GROUP	MODEL
Safety Recall Campaign	2022MY Sorento P/HEV (MQ4 P/HEV)
NUMBER	DATE
SC231	April 2022

## FRONT SEAT BELT PRETENSIONER REPLACEMENT (SC231)

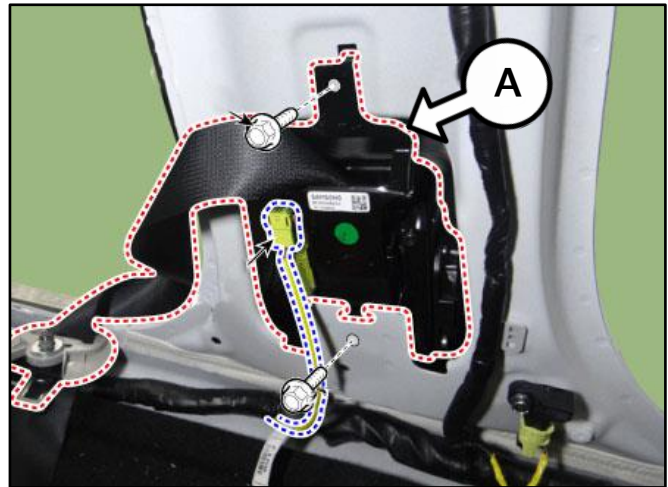
**BEFORE** replacing the seat belt pretensioner assembly, look up the vehicle in the "Vehicle Information" screen on WebDCS, then go to the "Campaign Not Performed" section. Look in the 'Campaign Description' field to determine which parts are to be replaced for each vehicle:

- RH = Right hand (passenger) side ONLY
- LH = Left hand (driver) side ONLY
- RH/LH = Both sides
